**BLOOMINGTON PLAN COMMISSION
STAFF REPORT
Location: 1722 N Walnut St**

**CASE #: SP-13-21
DATE: April 12, 2021**

Date: April 12, 2021
 To: Bloomington Plan Commission
 From: Bloomington Environmental Commission
 Subject: SP-13-21: VIVO Apt. LLC (Wyngate Inn)
 1722 N. Walnut Street

Comment Response Memorandum

1.) **LANDSCAPE PLAN**

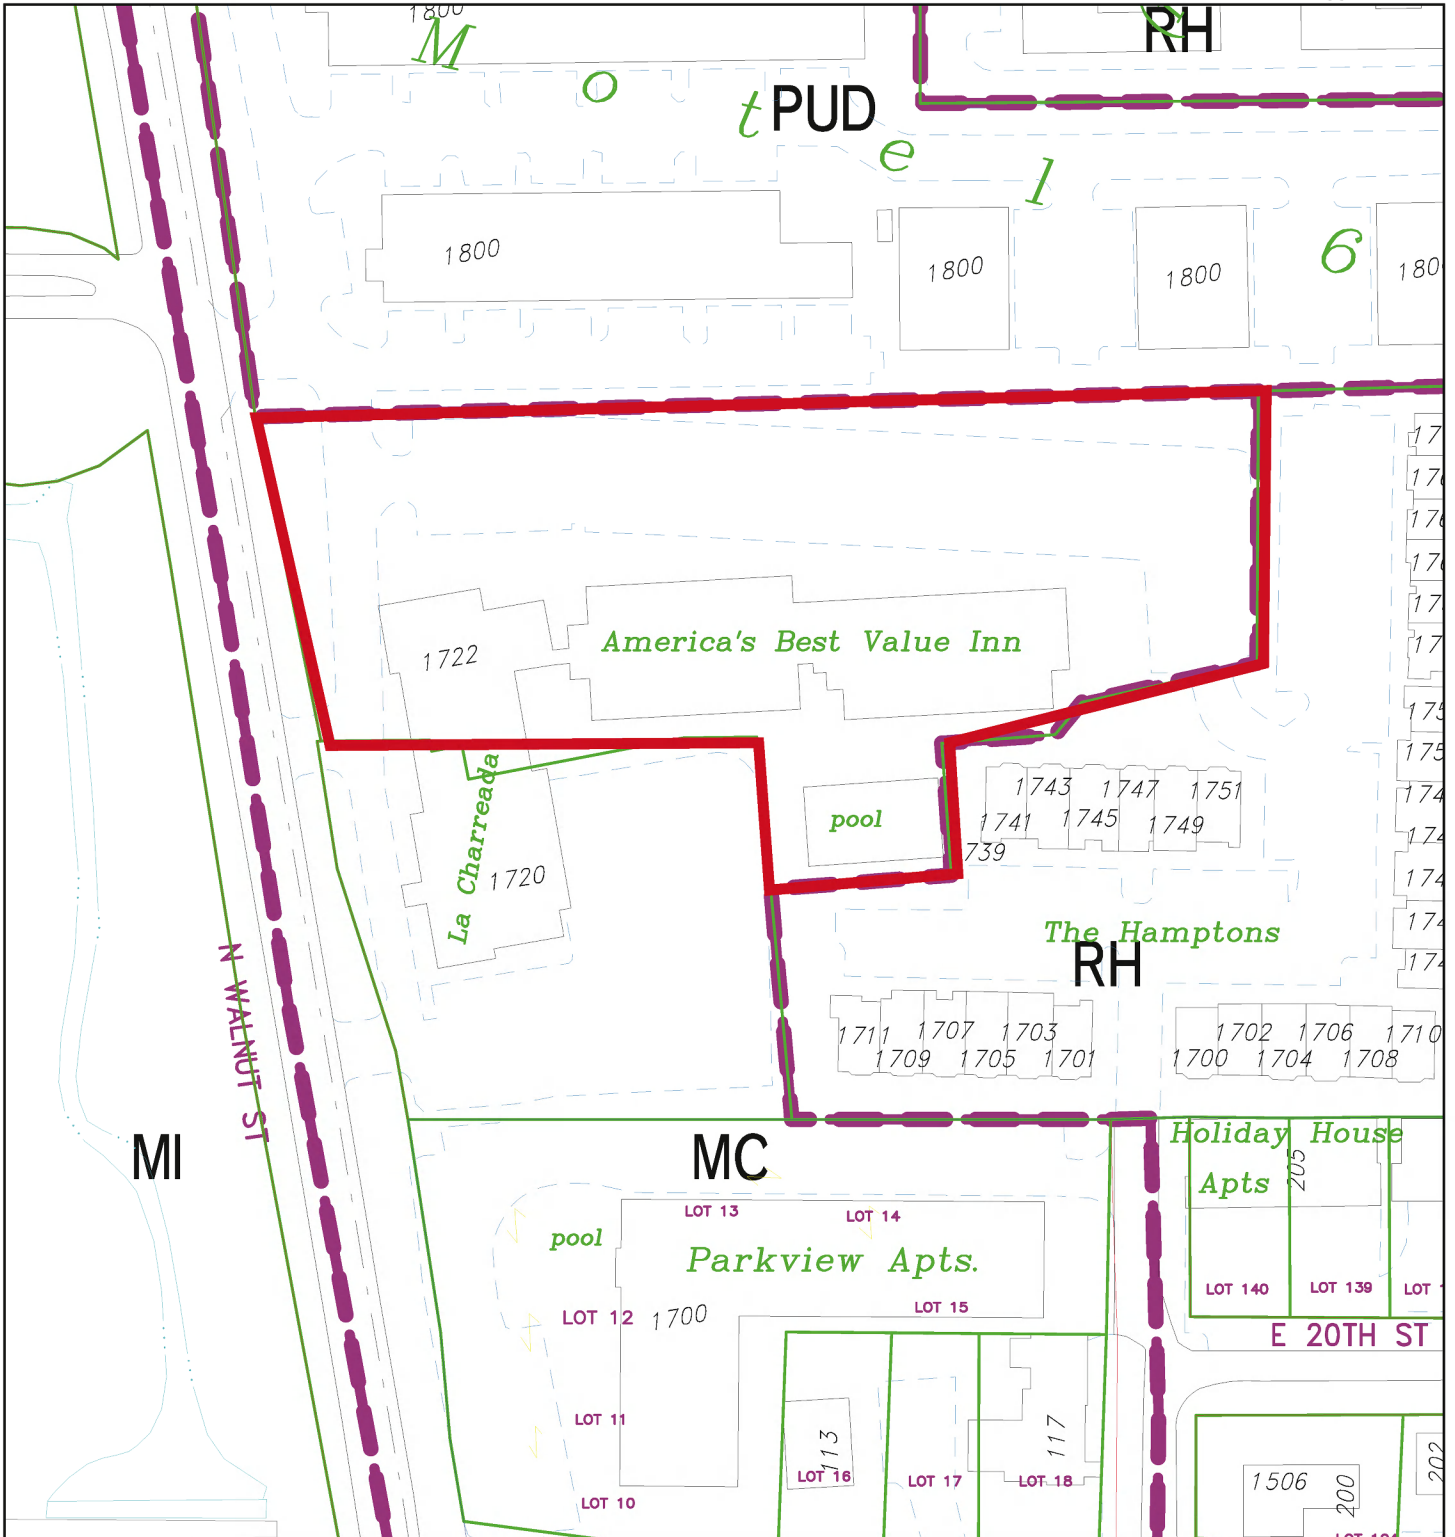
The Landscape Plan needs a bit of revision. The Petitioner has worked early and cooperatively to satisfy the requirements up to this point, thus the EC has no doubts that the plan will take very little to be in compliance.

- 1.) Revise the Landscape Plan prior to the Grading Permit issuance.
- 2.) Use all the green building products possible for the remodel.
